SLANE BYPASS & PUBLIC REALM ENHANCEMENT SCHEME

Additional Information Response Document

ABP-318573-23

Figure 4.1: Typical Illustration of a Geogrid Scour Prevention Mat

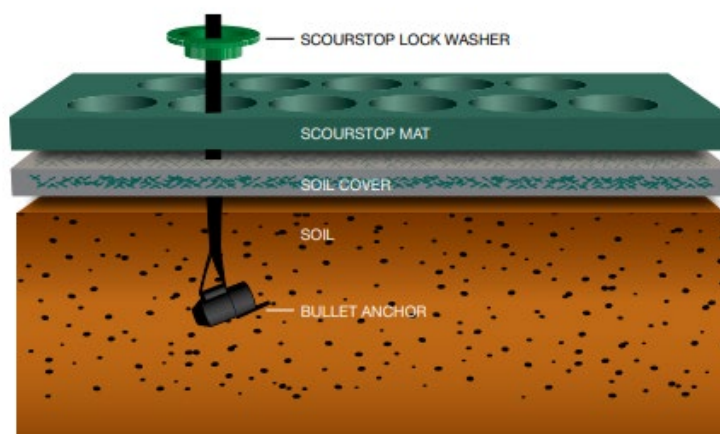
b) *"An exception is noted to the 10m exclusion zone from the riverbank (e.g. Natura Impact Statement Section 6.2.1.1.1.) for the construction of four outfalls. The applicant shall clarify if this relates to the scour mats shown in drawing DR0004. As there is no further reference to these works in the Natura Impact Statement or Environmental Impact Assessment Report Biodiversity chapters, provide an assessment of same, and describe any mitigation measures (e.g. manual installation, timing of works) required to avoid adverse effects to qualifying interest of the European Sites, or any other habitats, flora or fauna."*

The applicant confirms that the exception related to the 10 m exclusion zone from the riverbank is for the construction of the scour mats at two proposed outfalls to the River Boyne as illustrated on Vol. 3 – Scheme Drawings, drawing MDT0806-RPS-01-N2-DR-C-DR1004.

The proposed methodology includes for a geogrid scour prevention mat to be laid over the existing ground and anchored to depth within the underlying soils. See the typical illustration in **Figure 4.1** below.

To construct the scour protection within the 10 m riverbank exclusion zone, the scour mats are laid down on the existing ground surface by manual methods. To firmly secure the scour mats in place, anchors are manually hammered into the ground. This process firmly embeds the scour mat into the topsoil, anchored to the sub-soil and as the mats are a mesh construction, vegetation will continue to grow through the mat over time, restoring a completely natural appearance.

Map of Proposed Scheme Overlaid on MCC CDP Zoning

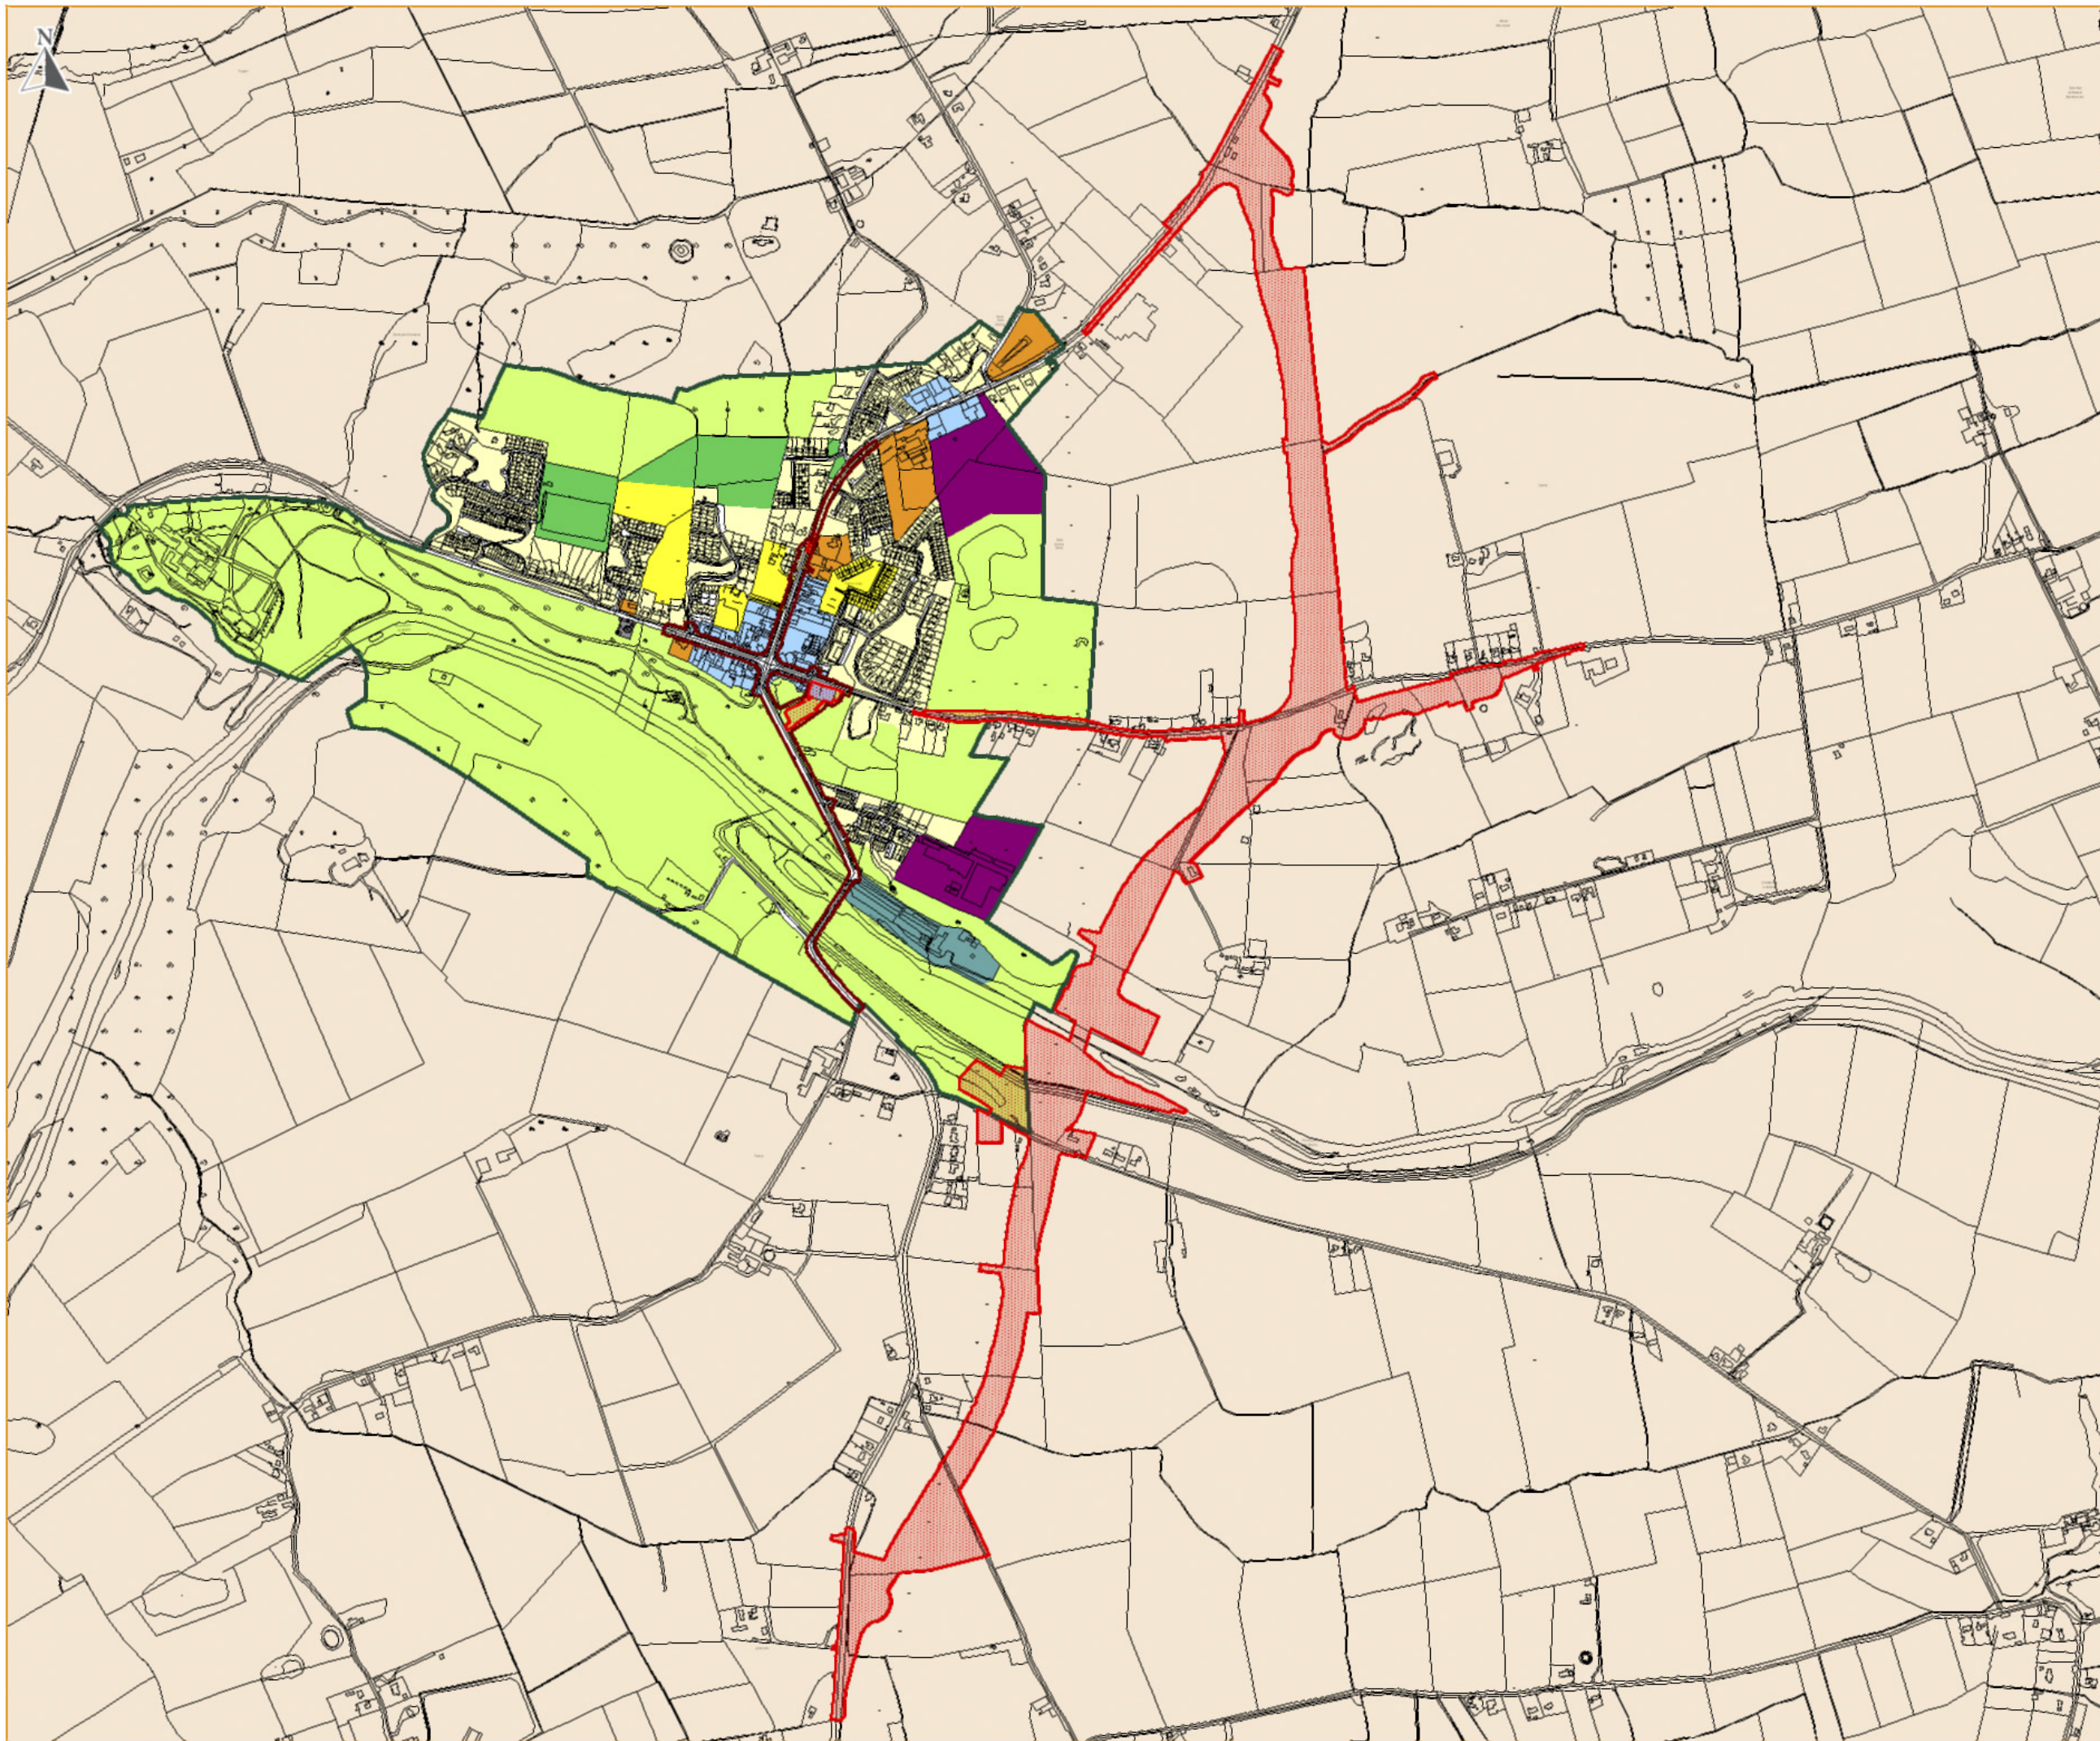
1. *“In the interest of clarity, please provide an overlay of the proposed development works on the land use zoning map for the area.”*
